Re: Response to Submissions (RtS) - SSD- 36138263
Augusta Street Warehouse and Distribution Centre
Augusta Street, Blacktown, NSW

In response to the letter from Blacktown City Council dated 17 June 2024 referenced MC-23-00005, we provide the following responses to the Civil Engineering and Drainage matters.

CO13904.03-SK-240801-01 - Infrastructure located within VPA.

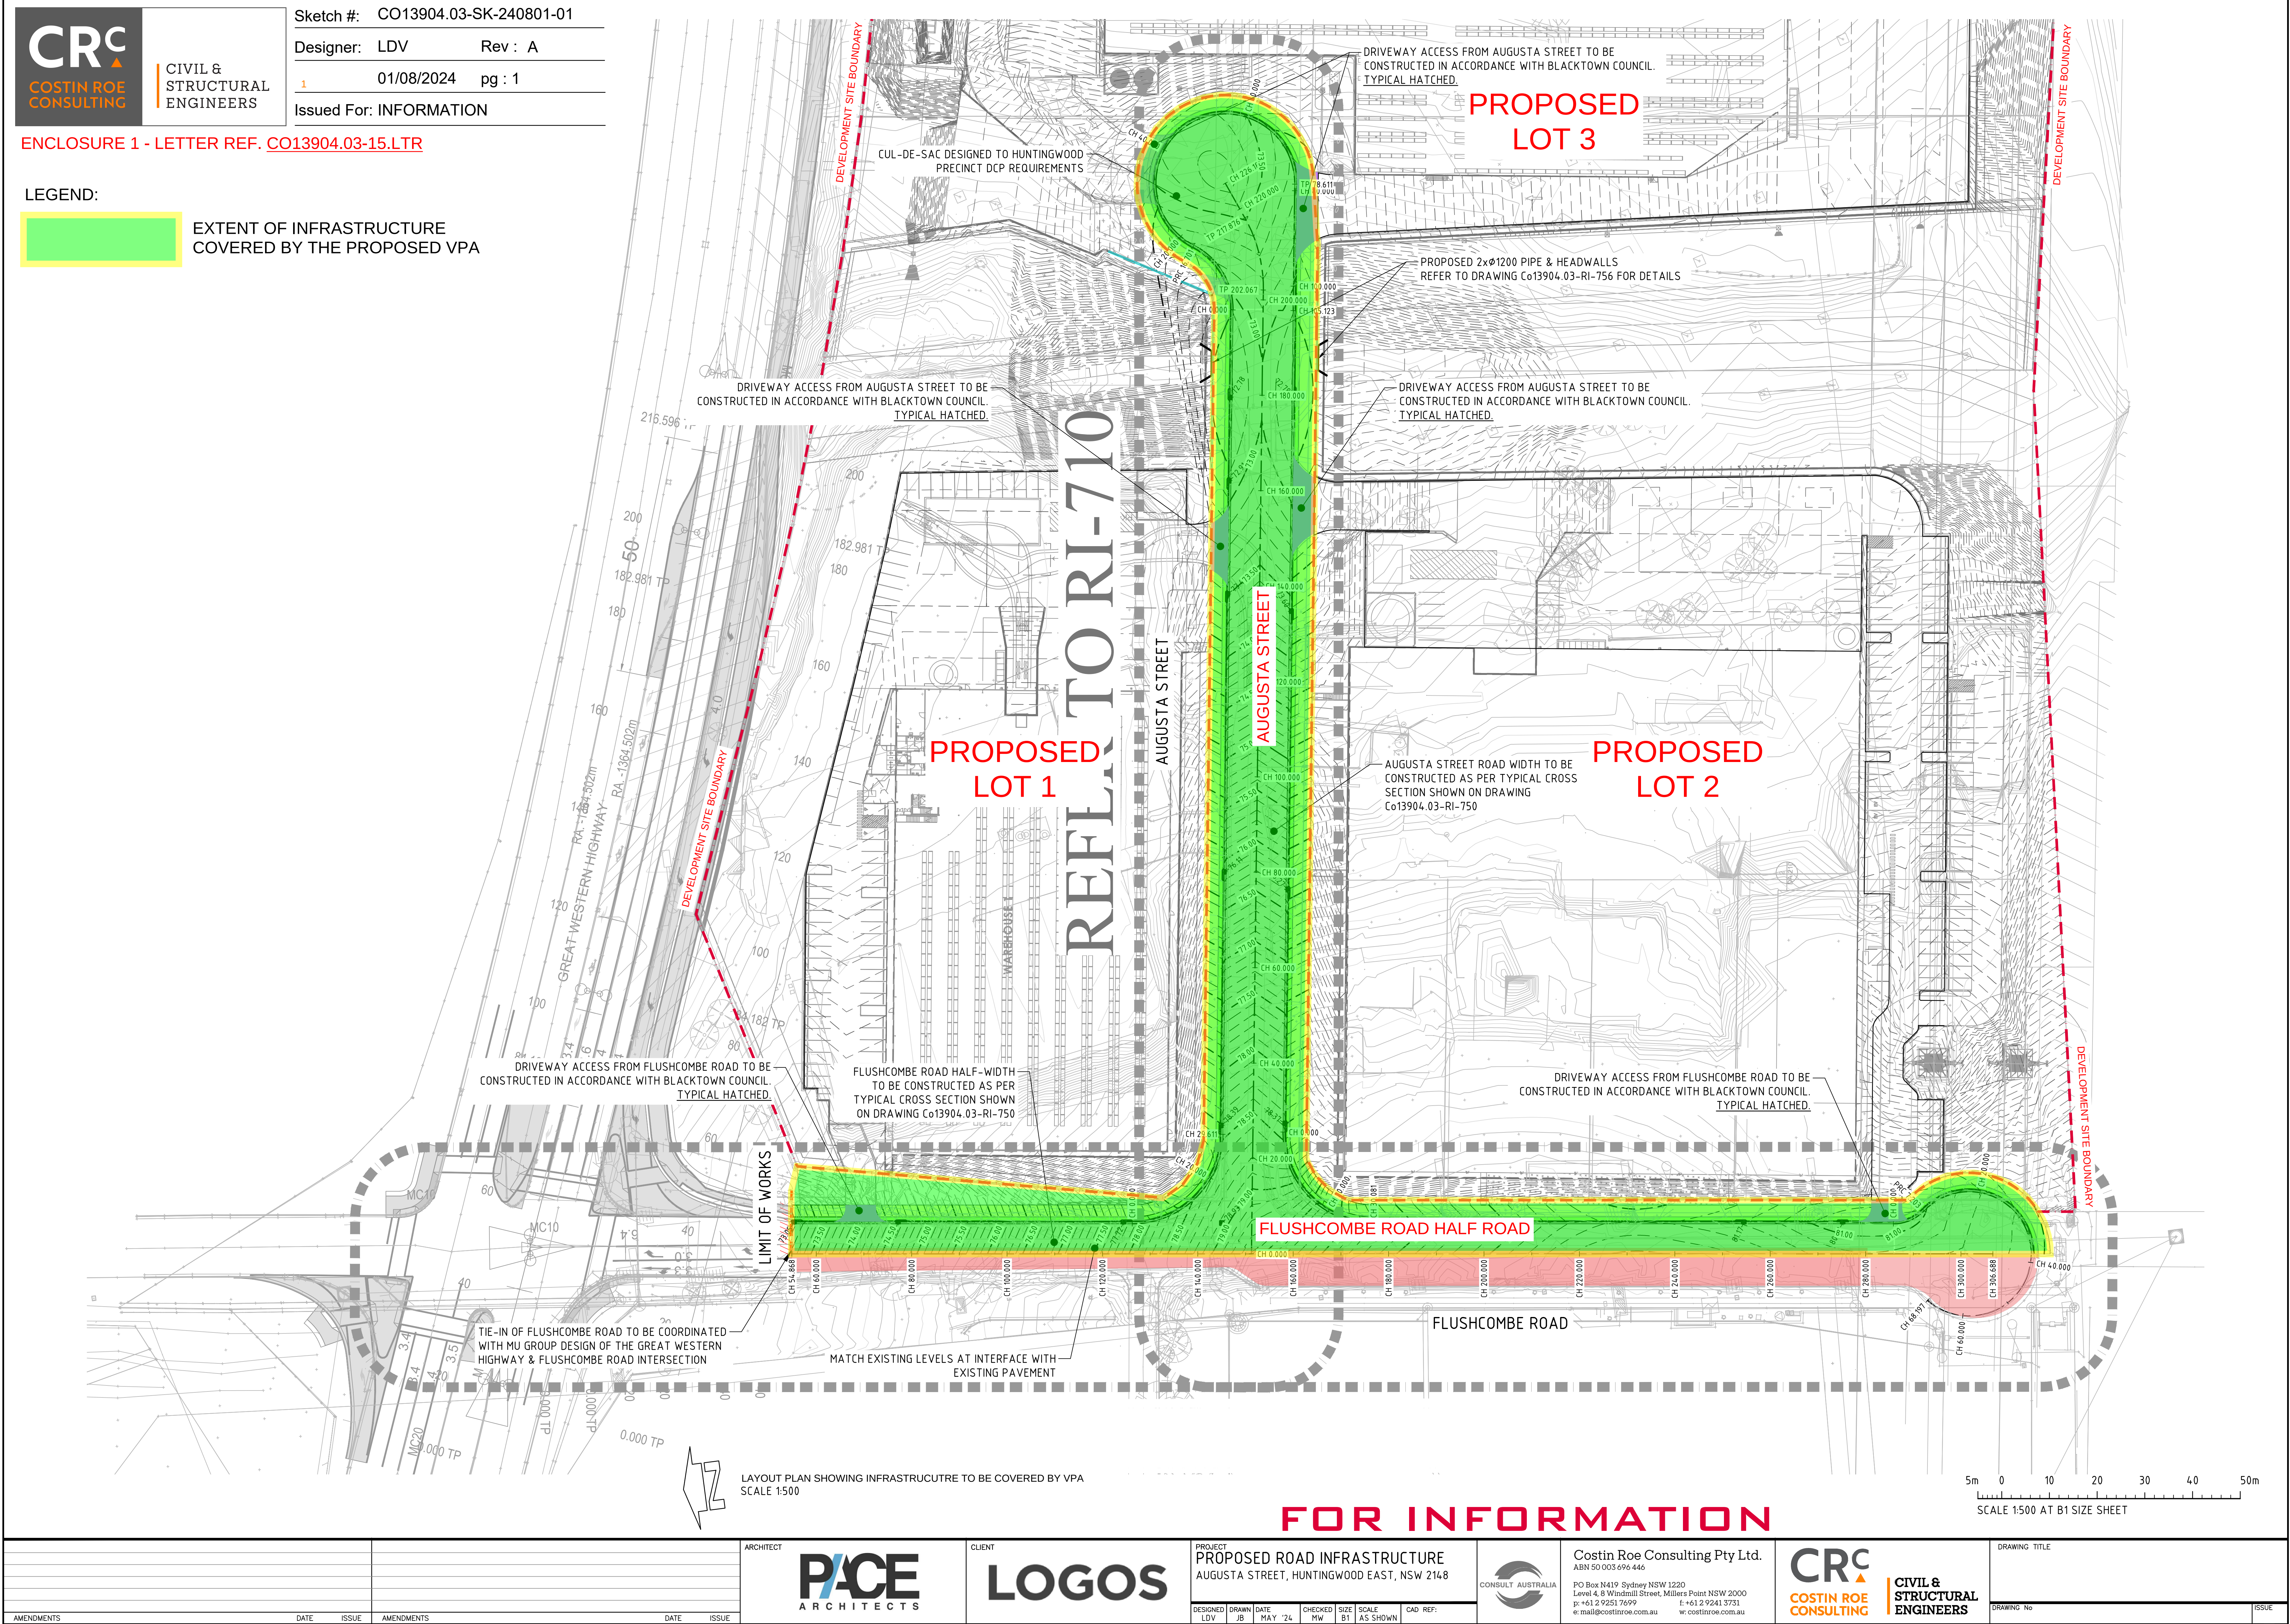
Item & Response		
No	ENGINEERING ISSUES	
	BCC Comment	CRC Response
1	The infrastructure to be covered by the VPA is to be provided so that the extent of engineering works to be conditioned by this consent can be ascertained.	The infrastructure located within the boundary of both Flushcombe Road (half-road) and Augusta Street. Refer to Enclosure 1 for a sketch showing the extent discussed above.
No	DRAINAGE ISSUES	
	BCC Comment	CRC Response
1	In the submitted OSD spreadsheet, the bypass areas are not consistent with the submitted plan. The applicant must demonstrate the actual catchment areas where discharged into the OSD tank and basin and the actual bypass area to the OSD. A catchment plan shall be provided.	Reference should be made to the new drawing added to the SSDA package, CO13904.03-SSDA472, showing the OSD catchment areas. The undeveloped pervious areas are not included in the OSD calculations.

Enclosure 1 – Sketch CO13904.03-SK-240801-01 - Infrastructure located within VPA.

DRAWING TITLE	FINISHED LEVELS PLAN WAREHOUSE 1 & 2
DRAWING No	C013904.03-SSDA501
ISSUE	H

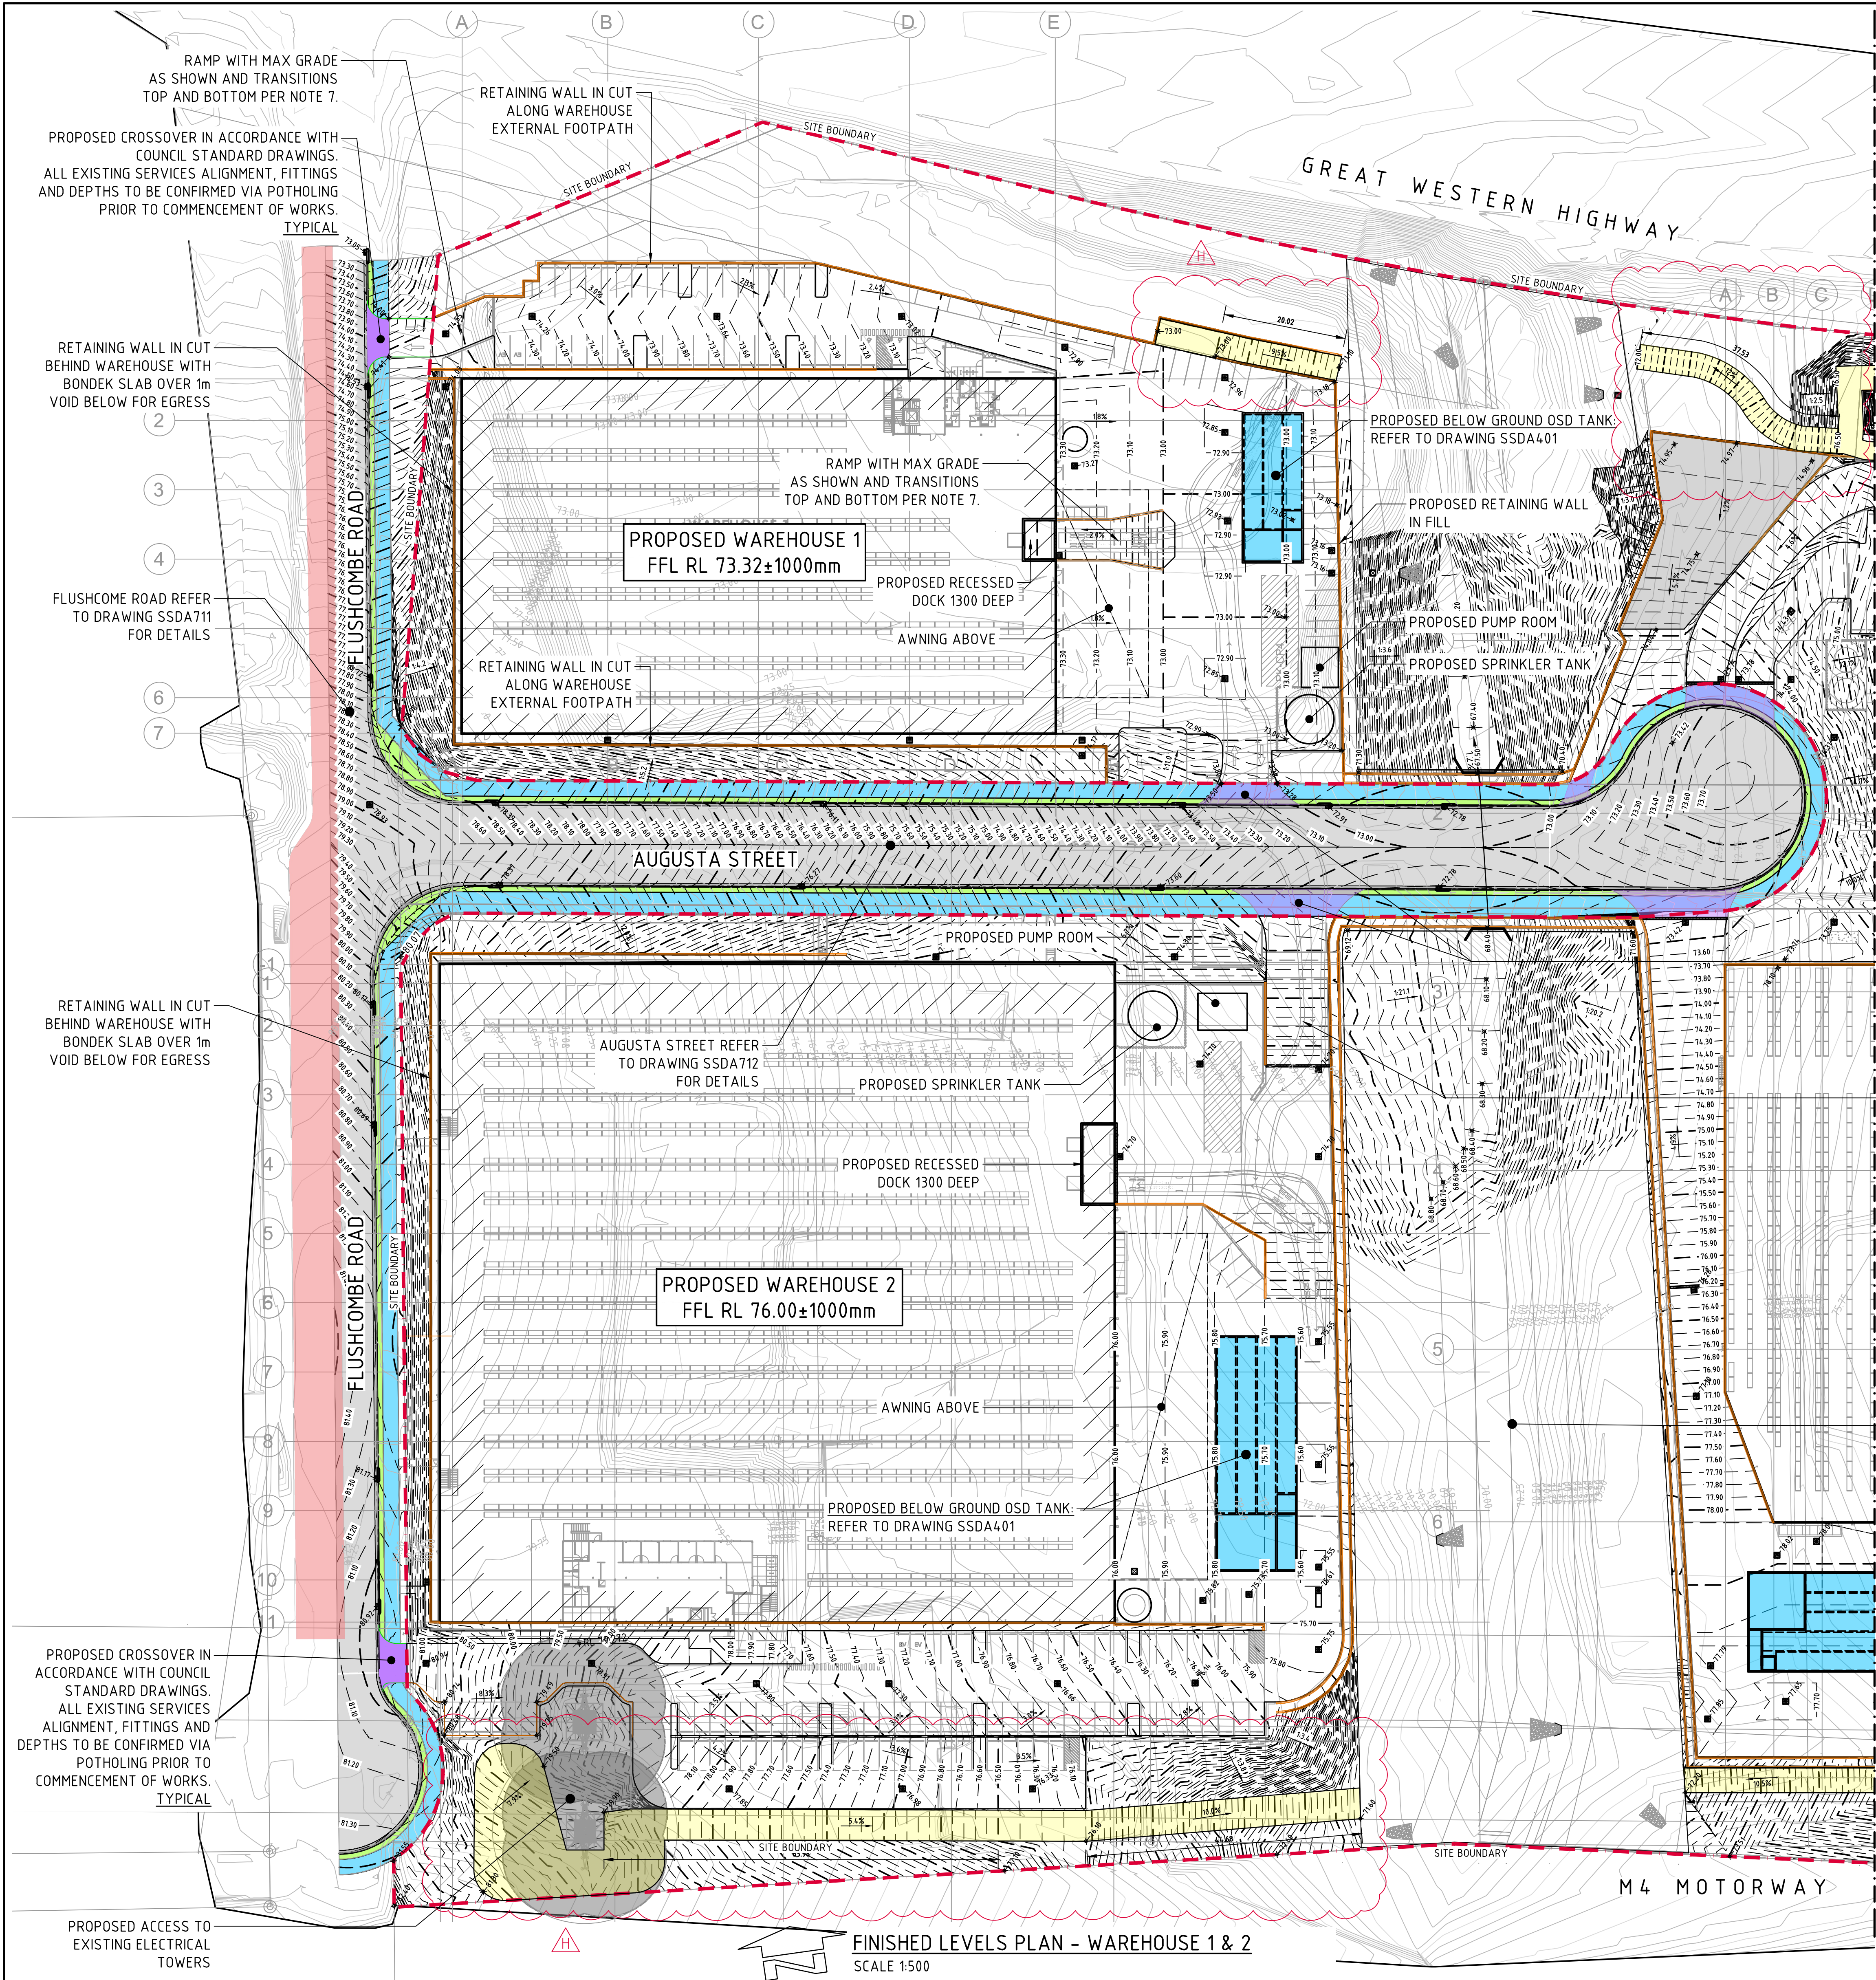
4	The longitude section of the access track shall be provided to prove the gradient is not more the 10%. Also, the access track must be at least 4 meter wide.	We note the request to provide longitudinal sections of the access tracks across the site. We have provided the necessary (requested) information in the updated drawing package in the format discussed below. The drawing package has been updated to indicate the conceptual finished surface levels at both the top and bottom of each ramp/track as well as a dimension indicating the concept length of the track. Additionally, the maximum slope of each access track is shown along the tracks (see drawings C501, C502, C503, and C504). This confirms that all access tracks will comply with the maximum gradient requirement of 10%. Extraction of long sections along these access tracks will require a certain level of 3D design deemed to be a detail design item. Please refer to the example below for the format in which these ramp grades are indicated.

All access tracks have been revised to be 4m wide.

Refer to Enclosure 2 for drawings C501 to C504 with updated maintenance access tracks shown and clouded for ease of reference.

ACCESS TRACKS DETAILS PROVIDED	07.08.24	H
ISSUED FOR STATE SIGNIFICANT DEVELOPMENT APPLICATION	05.08.24	G
AMENDMENTS	DATE	ISSUE
